THE BABCOCK & WILCOX COMPANY  
POWER GENERATION GROUP

7  
SITE INSTRUCTION NO. 6/202

Subj. Rapid Cooldown Transient of 4/23/78

Date May 8, 1978

ATTACHMENT # 1

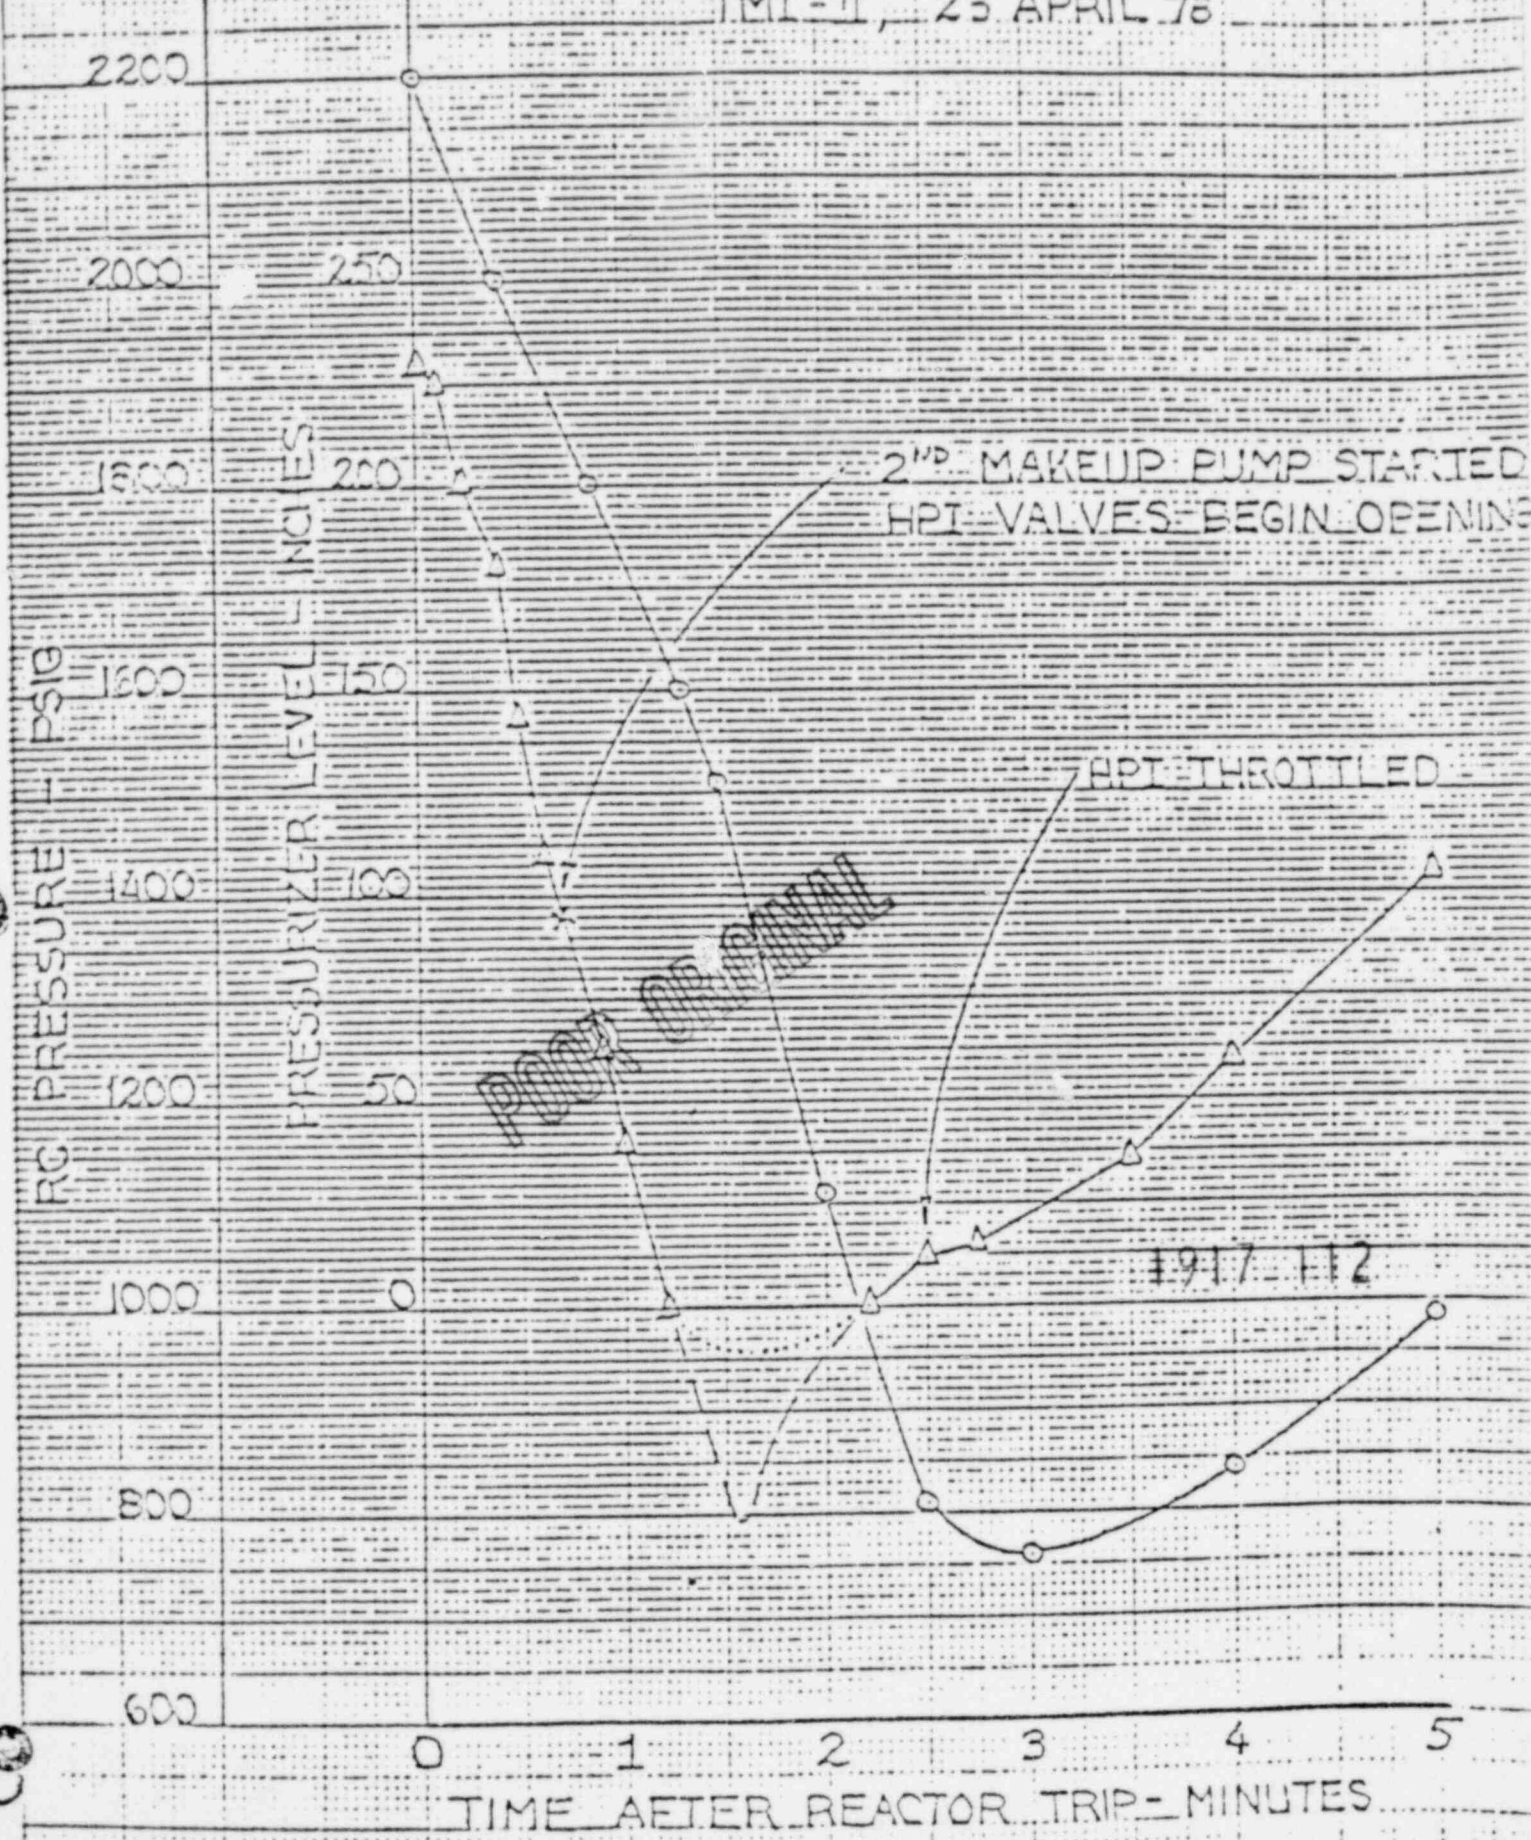
Attached (See Attachment 1) is a graph showing the temperature distribution in the support skirt during the critical transient times considered in the 620-0006-55 Stress Report. Since the RC temperature did not drop below 454 F during the initial cooldown, this transient should not produce a temperature gradient anymore severe than the condition analyzed in the stress report. Therefore, the affect of this transient on the support skirt would be the same as a 100 F/hr cooldown.
